BROWNS FERRY NUCLEAR PLANT (BFN) – UNITS 1, 2, AND 3 – TECHNICAL SPECIFICATIONS (TS) CHANGES TS-431 AND TS-418 – EXTENDED POWER UPRATE (EPU) – RESPONSE TO ACRS MEMBER CONCERNS AND RECOMMENDATIONS REGARDING CREDITING CONTAINMENT OVERPRESSURE (COP) CREDIT

RESPONSE TO MARCH 18, 2009 ACRS LETTER CONCLUSIONS AND RECOMMENDATIONS REGARDING CREDITING CONTAINMENT OVERPRESSURE (COP) CREDIT

RESPONSE TO NOVEMBER 10, 2008 ACRS LETTER CONCERNS REGARDING CONTAINMENT OVERPRESSURE (COP) CREDIT FOR BFN EPU

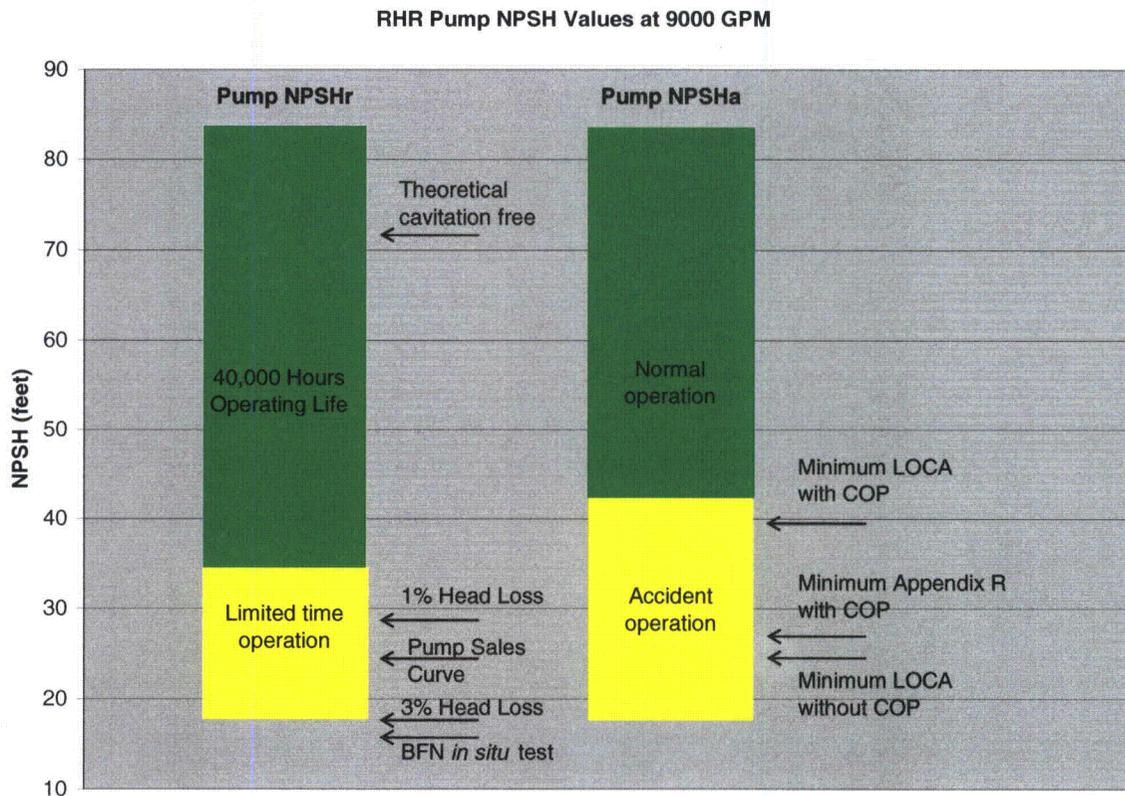
3) Pump Performance Data

In determining the required NPSH for given flow conditions, the pump vendor establishes required minimum NPSH values that correspond to operation at some degree of cavitation corresponding to 1% or 3% head loss.

- a) *For Browns Ferry RHR and CS pumps, explain if the 3% head loss was always used in determining the required NPSH or was the 1% criteria initially used for the Browns Ferry pump performance evaluation.*

In the past (prior to EPU), the NPSH/COP calculations used NPSHr values that were based on the original vendor performance testing conducted on each of BFN pumps commonly called the sales curves. The original RHR pump sales curve NPSHr values are approximately midway between the 1% and 3% head loss curves shown in Curve 2 of the BFN Sulzer report. For CS, the NPSHr values were also based on the CS pump sales curves and are greater than the 1% head loss curves at mid-range flows and approximately midway between the 1% and 3% head loss curves at high flows. A copy of the Sulzer report was included in the June 12, 2008, submittal.

Beginning in 2006, the EPU NPSH/COP analyses were performed with the pump vendor developed NPSHr values based on operation at reduced NPSH values for limited periods of operating time. These NPSH values are given in Curve 3 and 6 of the Sulzer report and are lower than the pump sales curves for short-term operating durations. TVA submitted the NPSH/COP calculations that used the 8000-hour NPSH values in the previously referenced August 31, 2006, calculations submittal.

In the alternative fire analysis NPSH calculation results that were provided in the June 12, 2008, submittal and later in the revised Appendix R licensing basis analysis results submitted on March 12, 2009 (ML090720951), TVA started using the 3% NPSHr values from Curve 2 of the Sulzer report for the RHR pumps. ANSI/HI 9.6.1-1998, "Centrifugal and Vertical Pumps for NPSH Margin" defines NPSHr as the NPSH that will cause total head to be reduced by 3%. Use of the 3% curves provided a reduction of several feet in NPSHr and lessened the magnitude and duration of required COP. The below figure illustrates the NPSH values that have been used to evaluate RHR pumps in relationship to pump operation.
